# UNITED STATES PATENT AND TRADEMARK OFFICE

**Office Action Summary**

10/773,016

## DETAILED ACTION

**Figure 5 (Longardner)**

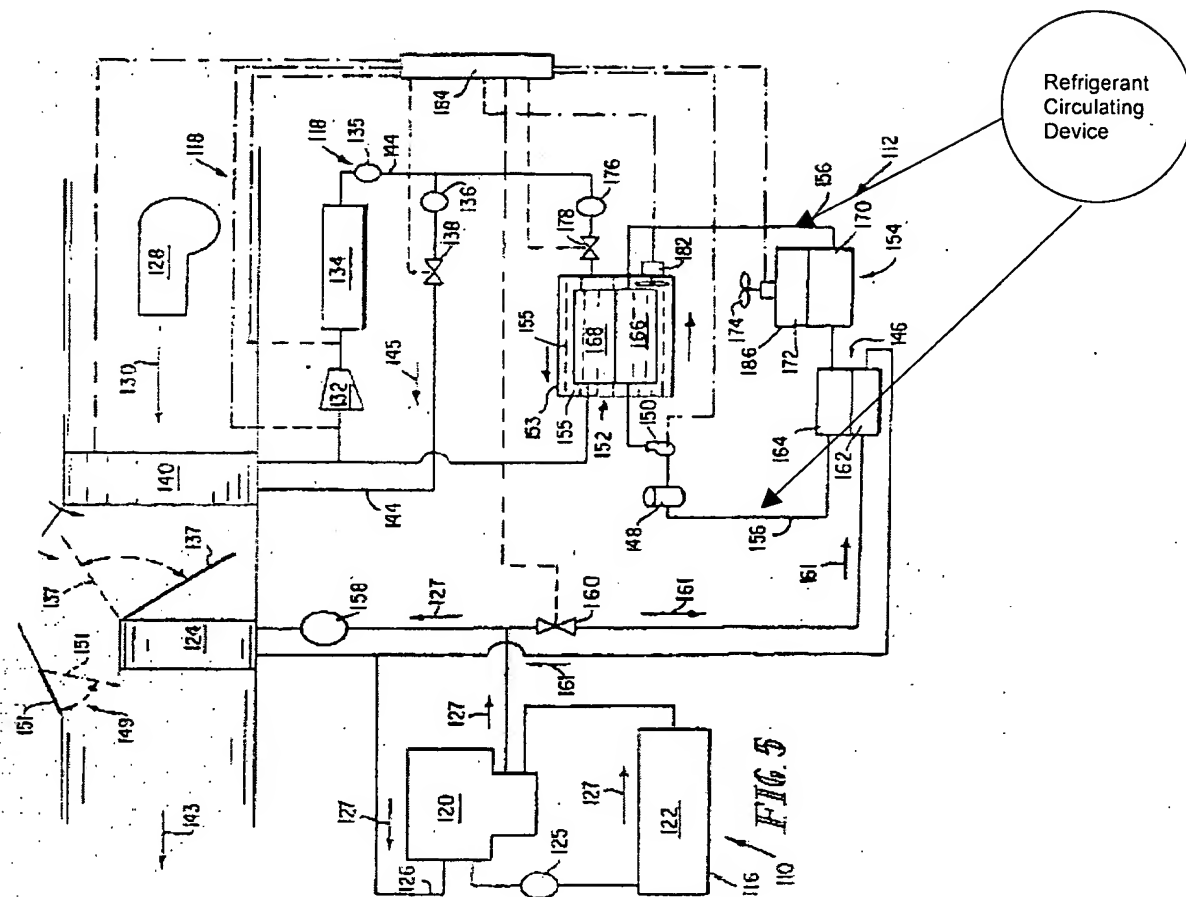
Regarding claims 1 and 6, Longardner discloses a thermal energy storage system connected to an air conditioning system. The system comprises a compressor 132 capable of compressing a refrigerant, a condenser 134 connected to the compressor (see Figure 5), an expansion valve 136 and an evaporator unit 140 in heat exchange relationship with an air stream (column 11 lines 10-23). Longardner further discloses a thermal energy storage unit 112 with a tank 152 having a storage medium and an associated heat exchanger 146 between the condenser and evaporator (column 12 lines 29-37). Longardner further teaches a refrigerant circulating device 156, capable of circulating refrigerant through the heat exchanger, between the tank, condenser and evaporator (column 12 lines 29-37, 62-68 and column 13 lines 1-10 and Figure 5). The refrigerant circulating device includes a prime mover 150 and an auxiliary liquid (column 12 lines 40-44 and Figure 5), with the force of the prime mover exerted on the auxiliary liquid being indirectly transferred to the refrigerant (column 12 lines 45-68 and column 13 lines 1-10).

Claims 1 and 6 differ from Longardner in calling for a prime mover mechanically coupled with fluid cylinders to circulate the refrigerant and further differs in calling for flexible bladders located within each of the fluid cylinders. Longardner teaches a prime mover 150 mechanically coupled to an engine 120 (column 10 lines 42-56 and column 12 lines 29-68 and column 13 lines 1-10). Clark Jr. discloses a thermally powered engine 10 with two fluid cylinders 22, and 24. Longardner teaches a thermal storage system 112, connected to an air conditioning system, coupled to an engine 120 by the

Figure 6 (Clark Jr.)

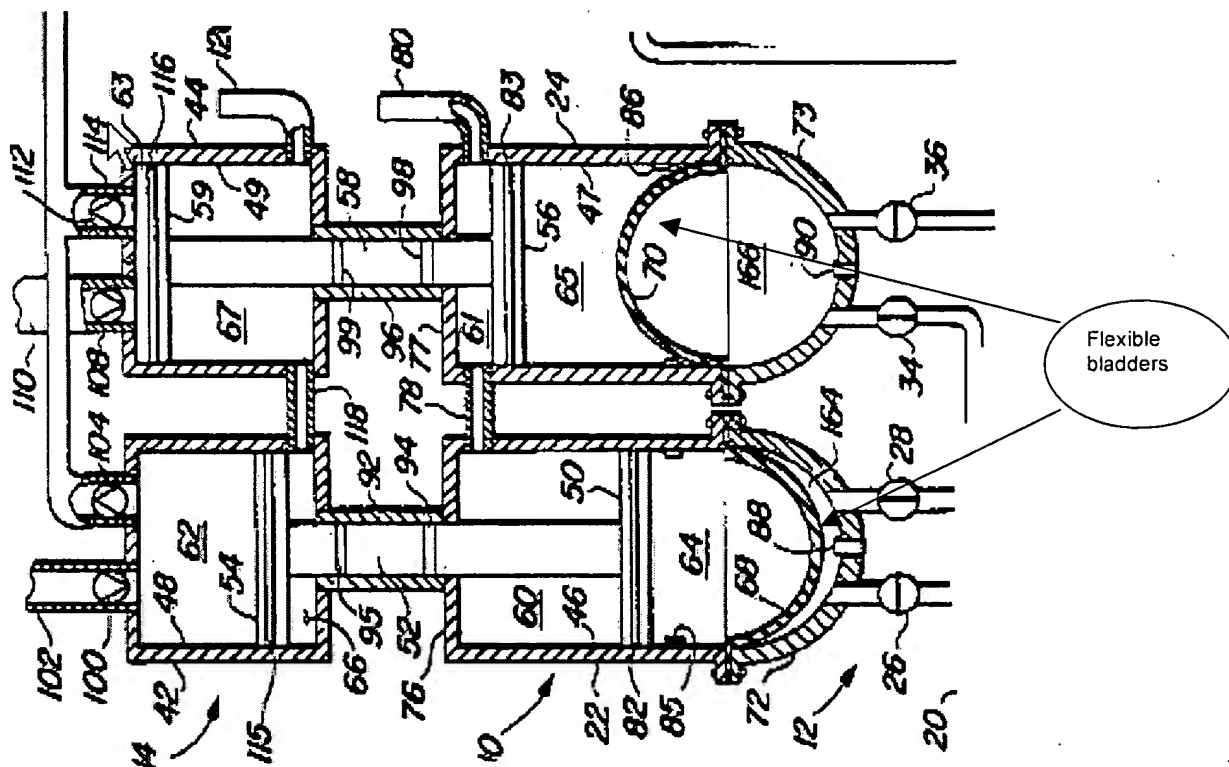
engine coolant loop system 116 (column 10 lines 42-56 and column 12 lines 29-68 and column 13 lines 1-10). Modifying the engine of Longardner with the engine of Clark Jr. enables the prime mover 150 of Longardner to be coupled with the pistons 50 and 56 of cylinders 22 and 24 of the Clark Jr. engine during the pump's 150 operation (column 10 lines 42-56 and column 12 lines 29-68 and column 13 lines 1-10). At the time of the invention it would have been obvious to one of ordinary skill in the art to modify the engine of Longardner with Clark Jr. because coupling piston's with the prime mover greatly increases the amount of work done on the refrigerant being circulated. Simple fluid mechanics teaches the amount of work done on the refrigerant due to the prime mover acting alone is far less than the amount of work done on the refrigerant when the prime mover is coupled with a hydraulic cylinder with fluid. Clark Jr. does not specify oil as the fluid used in the cylinders. It would have been obvious to one of ordinary skill in the art to use oil, as it well known in the art that oil is incompressible and thus increases the efficiency of the hydraulic cylinder. Clark Jr. further teaches flexible bladders 68 and 70 located within each of the fluid cylinders, see Figure 6.
